CITY OF ALBUQUERQUE

Planning Department
Alan Varela, Director

**Re: Retail at 7 Bar
10080 & 10088 Coors Blvd NW
Conceptual Traffic Circulation Layout for DFT Approval
Engineer's Stamp 9-25-24 (B14D010D)**

RETAIL AT 7 BAR ALBUQUERQUE, NM	DRAWN BY pm/g6sb
	TRAFFIC CIRCULATION LAYOUT	DATE 09-25-24
	 5571 MIDWAY PARK PL NE ALBUQUERQUE, NEW MEXICO 87109 (505) 858-3100 www.tierrawestllc.com	DRAWING
SHEET # 9		JOB # 2023004

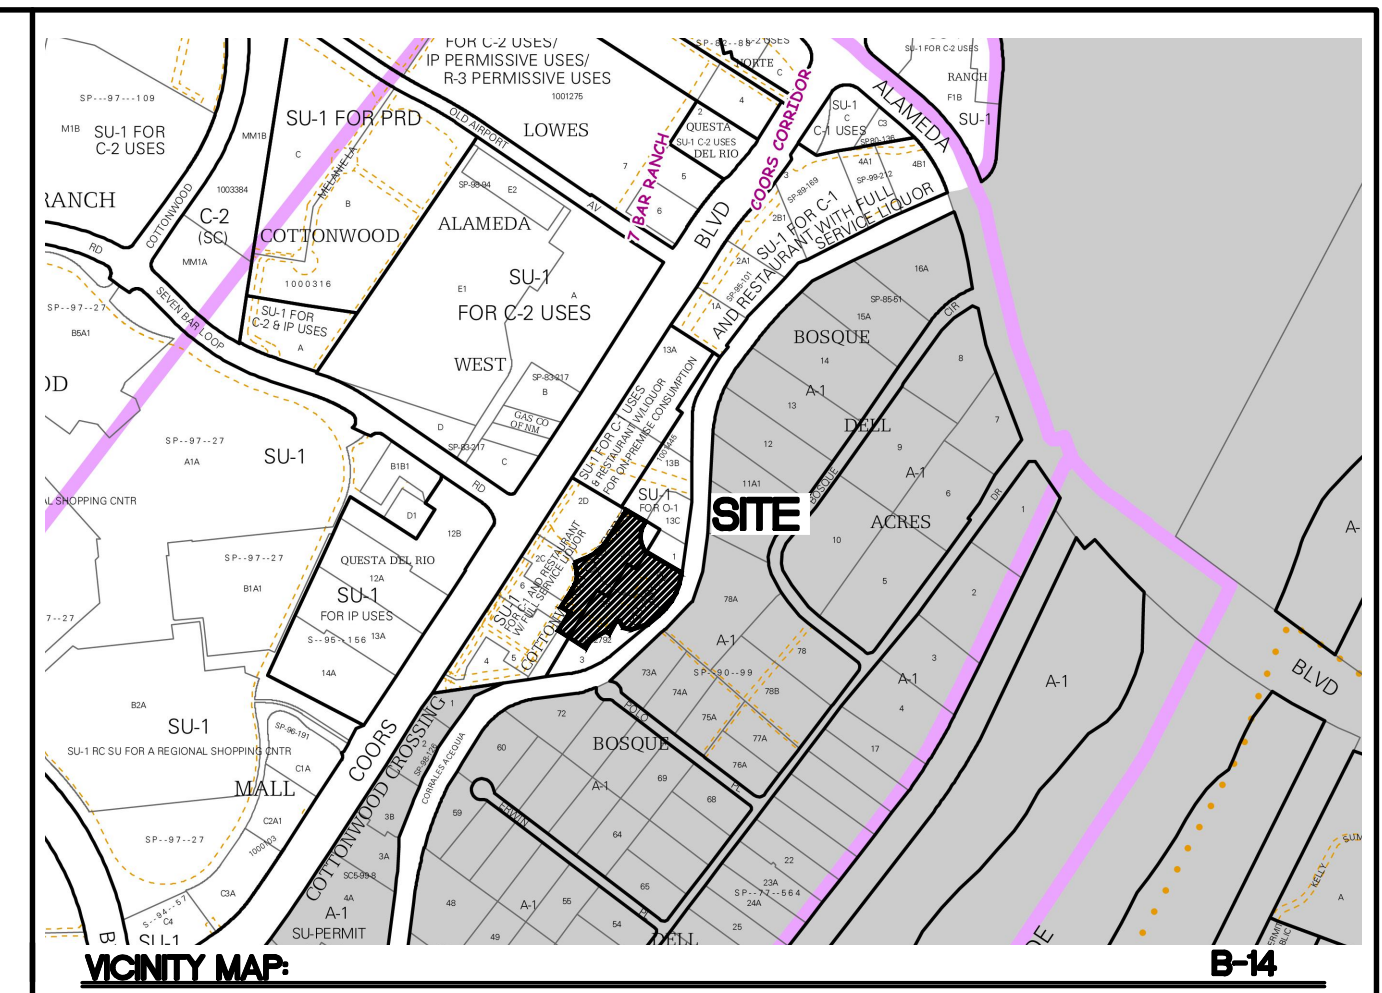
1-A 5 ft sidewalk and 4-6 ft Buffer/Landscape are required along 7 Bar loop and the access road.

2-Show all the detail drawings

3-provide approval of fire marshal and solid waste dept.

4-submit TSF (see attached)
